City of Torrington

Memorandum

RE: Engineering Review No. 1 - Site plan Application for 93 Main Street

Hampton Inn Property Improvements prepared for Yankee Pedlar Inn (Jayson Hospitality LLC)
prepared by Allied Engineering Associates Inc

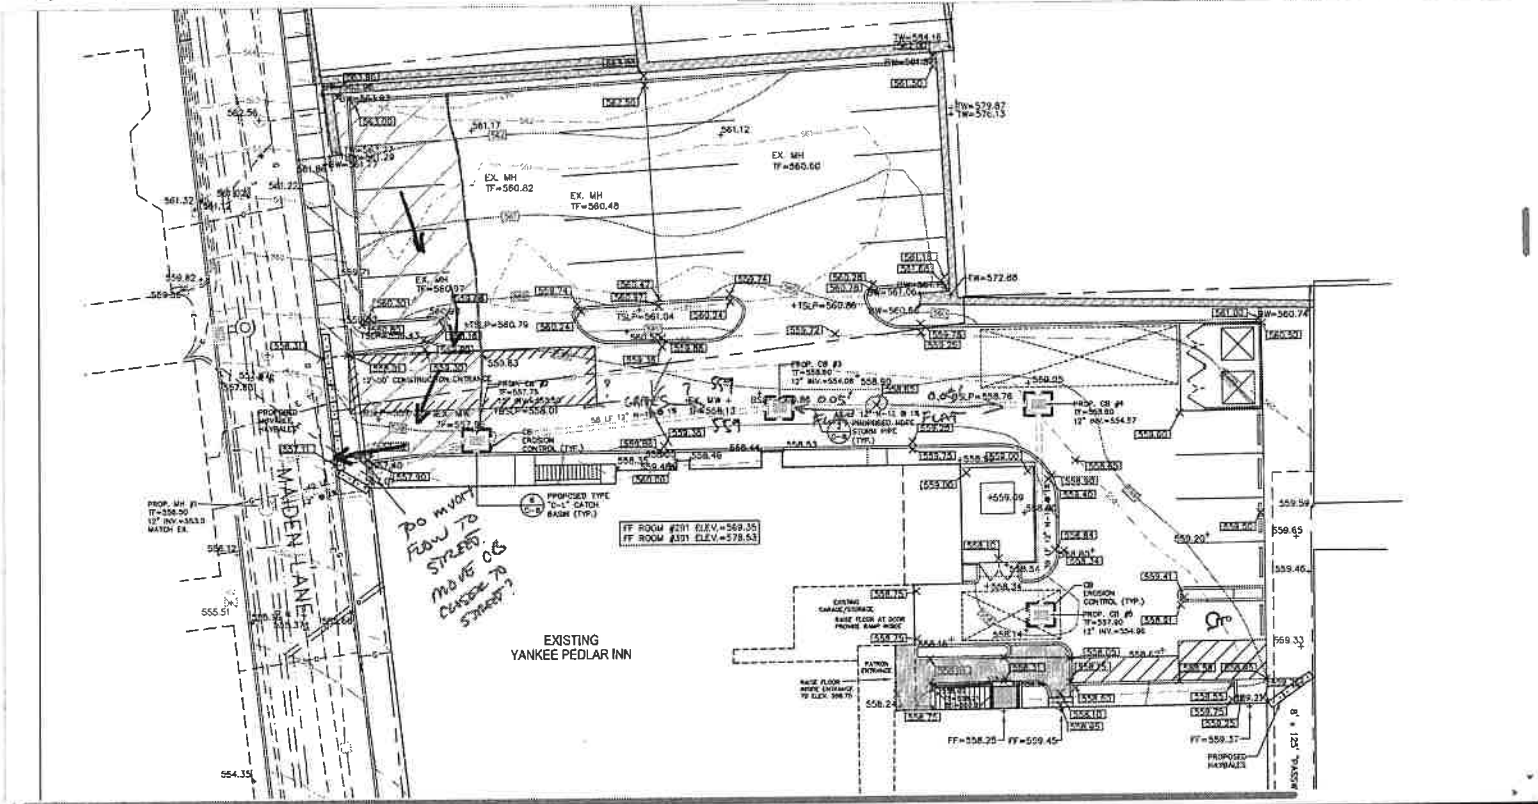
22. Confirm the double lighted identification sign will not obstruct sight lines to the west.
23. C-4 drainage
 - a. there appears to be a significant portion of the parking lot that drains into the street (green hatched area on marked up attachment). CB 2 should be moved closer to the street or the site re-graded to minimize the amount of runoff across the sidewalk and into the street.

- b. See marked up attachment – the area between CB3 and CB2 needs more grades to understand the direction of the flow.
 - c. The area between CB3 and CB4 appears to be very flat at 0.5 inch drop over 25 feet in both directions, confirm.
